FREDERICK COUNTY PLANNING COMMISSION

TITLE: **Barrick's Garden Center**

FILE NUMBER: **SP 11-13 (AP #12221, APFO #12222 & FRO #12223)**

REQUEST: **Site Plan**

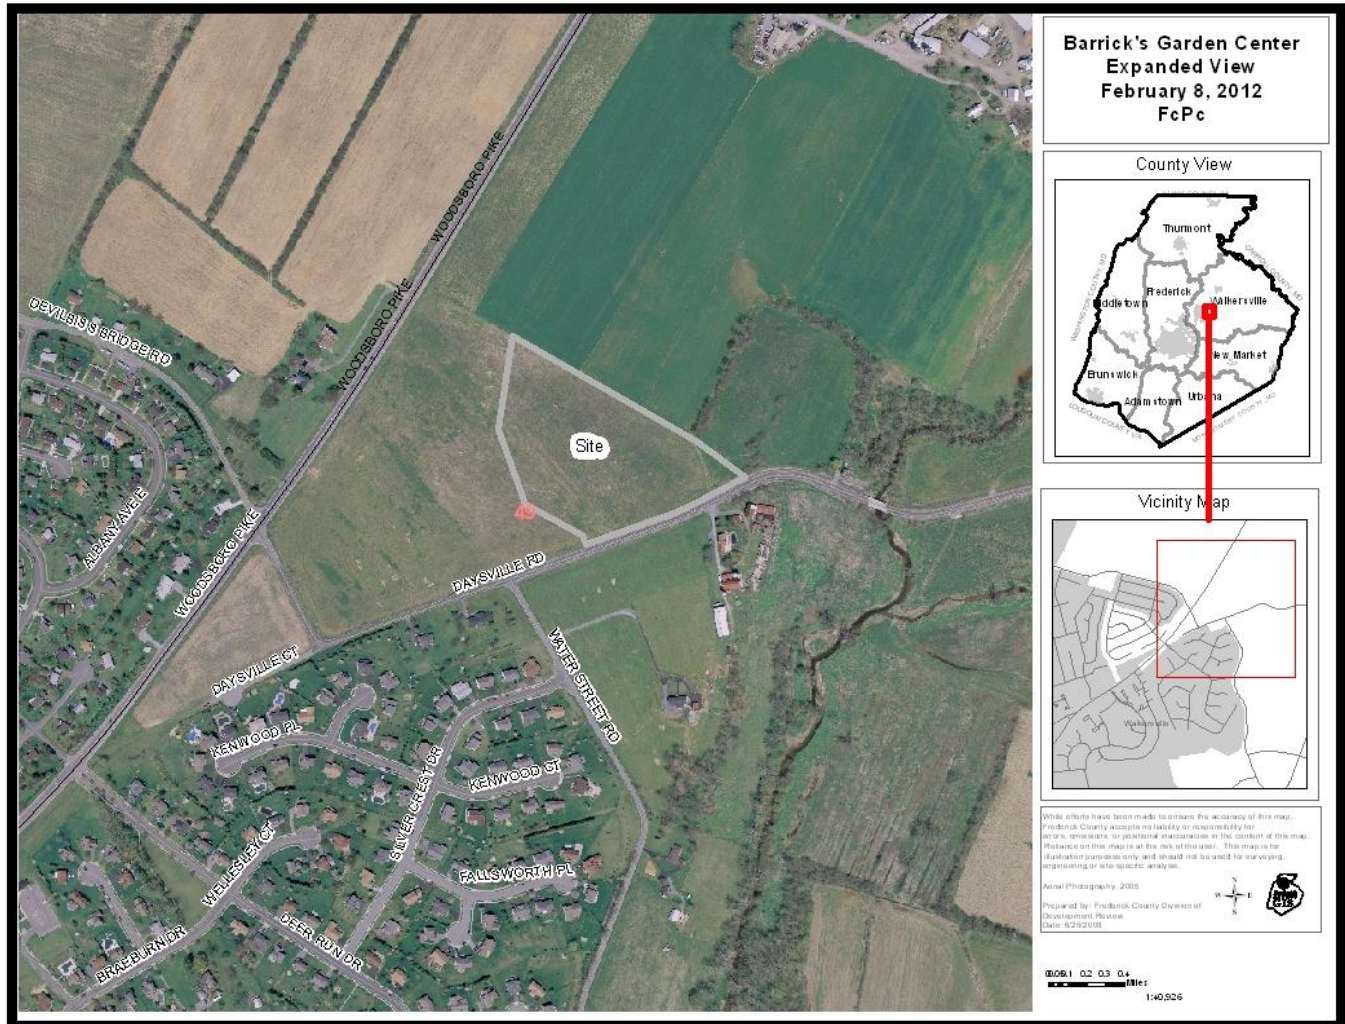
The Applicant is requesting site plan approval for a 5,600 square foot retail garden center and nursery, on an 8.73-acre site. This plan also proposes a 23-space employee/customer parking area.

Dimensional Requirements/Bulk Standards: Section 1-19-6.100 of the Zoning Ordinance stipulates the setback requirements and the minimum lot area for the proposed use. The setback requirements are 40-foot front yard, 50-foot rear yard, and 50-foot side yards. The maximum height allowed is 30 feet. The minimum lot size is 5 acres. The proposed plan meets the Bulk/Dimensional requirements.

Access/Circulation: The access will be via a full-movement, 30' wide, two-lane access situated along Daysville Road, east of Water Street. Daysville Road is a 22' bituminous pavement with an 8' wide bituminous shoulders, and is designated as a collector with access to a minor arterial at the Water Street intersection. No accel/decel or left turn lanes are warranted due to expected low volumes of accessing traffic.

Parking: Pursuant to §1-19-6.220 of the Zoning Ordinance, 1 space is required for every 300 square feet of office floor area and 1 space is required for every 250 square feet of retail floor area. Therefore, 1,690 square feet of office floor area requires 7 spaces (due to rounding of separate 1st and 2nd floor requirements). The 1,350 square feet of retail floor area requires 6 spaces. In addition, the proposed use will have eight employees, which generally requires an additional 4 parking spaces at 1 space/2 employees. Therefore, total parking spaces required are 17; the Applicant is proposing 23, including 2 ADA accessible spaces. Note the remaining building area is common areas, corridors/stairways, bathrooms, etc... and not applicable.

Loading Area: Pursuant to §1-19-6.210 of the Zoning Ordinance the site should accommodate one small loading space. The Applicant has shown 1-small (10'x20') loading space in the front of the principal structure.

Landscaping: The Applicant has worked with Staff in order to propose a landscape plan throughout this site. The Applicant has also provided substantial landscaping along the entire Daysville Road frontage, the parking areas and mulch storage areas are also screened with landscaping. The Applicant is locating the nursery stock for the facility to the rear of the building in order to provide additional screening of the site from the neighboring property. The landscaping contains a variety of plant species, which provide screening as well as aesthetics. The planting schedule follows the standard sizes that have been approved by the Planning Commission.

Lighting: Site lighting is provided by dusk to dawn building mounted lights. A total of four lights (housing two-175 watt fixtures each) will be provided, one at each building corner. All lighting will be placed in such a manner as to eliminate glare onto streets or adjoining properties.

The Applicant has noted on the plan that lighting will not exceed 0.5 ft/candles at the periphery of the site and lighting will be directional onto the site through the use of shielding and lighting orientation in accordance with the lighting provisions of §1-19-6.500. Due to the fact that the proposed lighting includes only wall mounted fixtures, no separate lighting plan is necessary.

Signage: The site is allowed a maximum of 25 square feet of signage with a maximum height of 15 feet. The Applicant has proposed a 24.4 sq ft sign with a maximum height of 12 feet. The proposed signage complies with all applicable code requirements.
